BURLINGTON DEVELOPMENT REVIEW BOARD Tuesday April 4, 2017, 5:00 PM Conference Room 12 PUBLIC HEARING NOTICE

BURLINGTON DEVELOPMENT REVIEW BOARD Tuesday, April 4, 2017, 5:00 PM Conference Room 12, City Hall, 149 Church St, Burlington, VT AGENDA

To: Development Review Board
From: Mary O'Neil, AICP, Principal Planner
Date: April 4, 2017
RE: ZP17-0791CA; 323-325 College Street

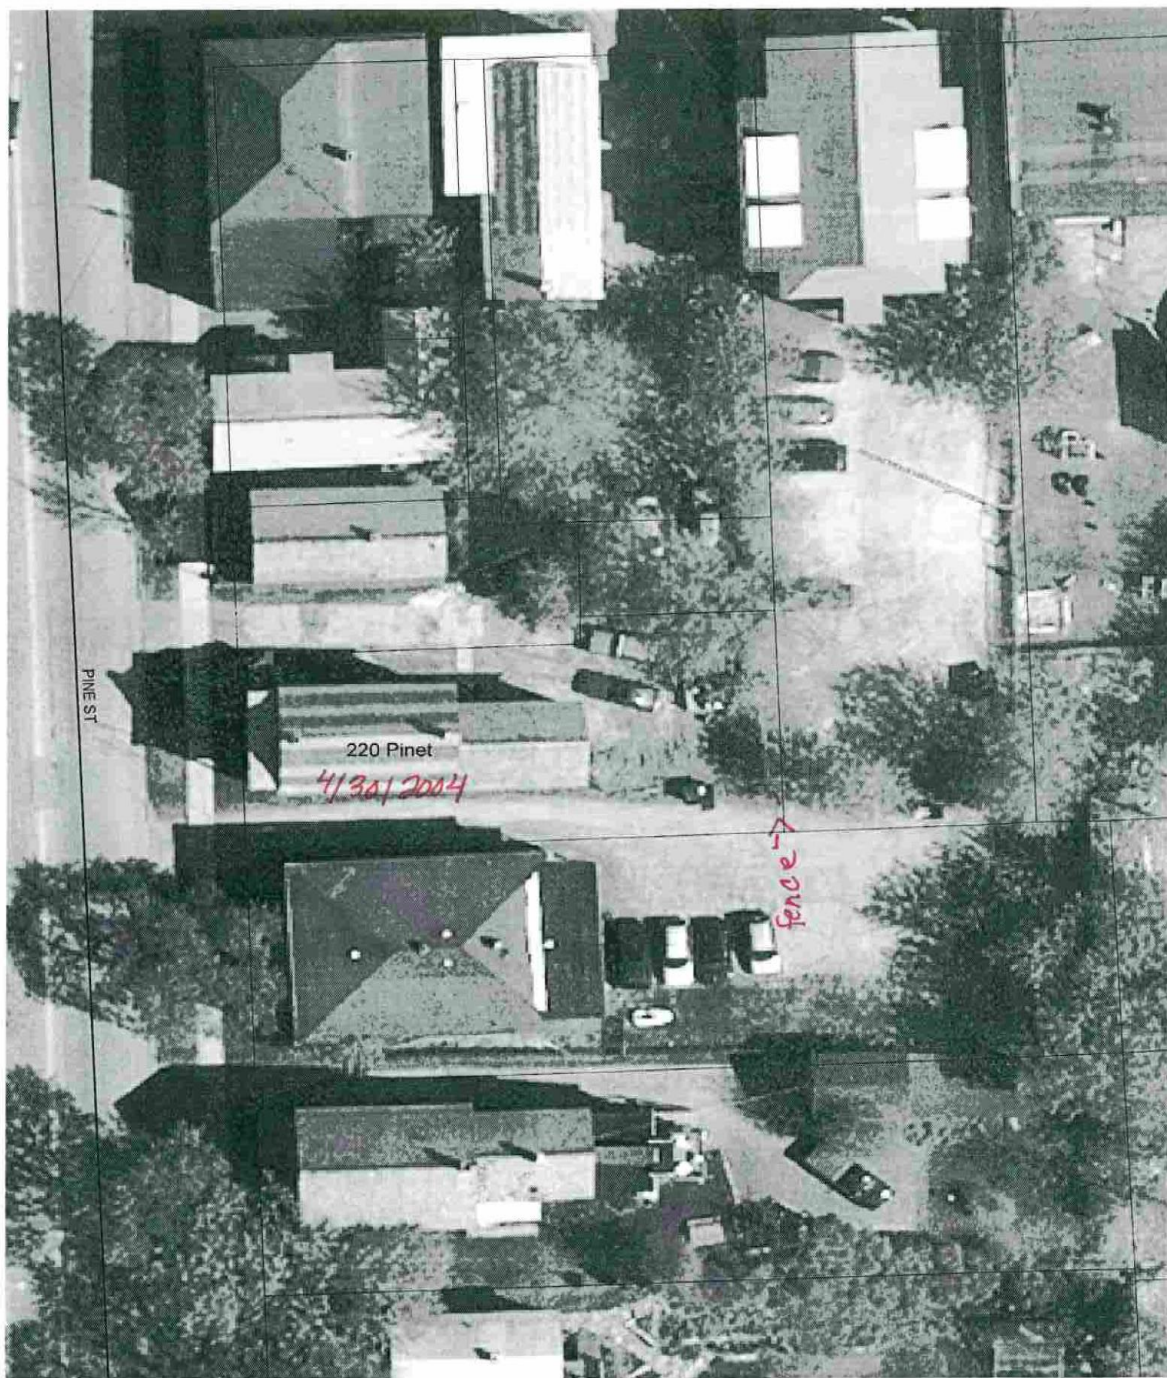
These two vehicles appear to coincide with the "Triangle" parking. Parking has expanded. The average width of a car is 9' so this appears to coincide with the 20' wide (top of) "Triangle" indicated on the 1991 site plan.

This picture is taken from Pine Street (west to east). This is the shared driveway (shared with property to the north). As you can see, the driveway has widened, vehicles have eased off the driveway and eroded grass; thus widening the driveway without permits. The two vehicles veered off the driveway appear to have veered off the “triangle” of the 1991 site plan indicating where parking was. NOTE: these trash receptacles were never shown on any site plan.

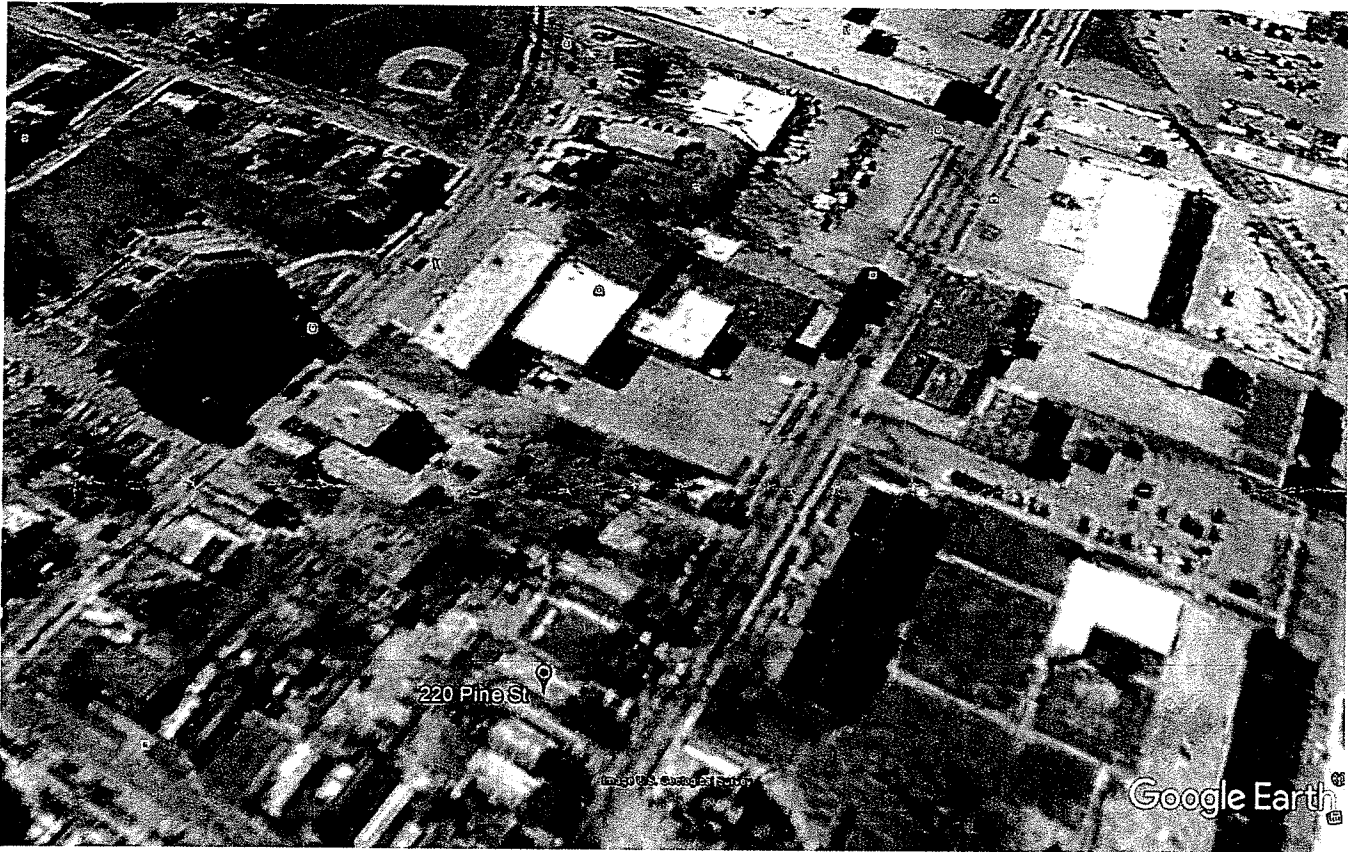
These two parking spaces are shown in the 2004 Aerial Image. Driveway has been widened.
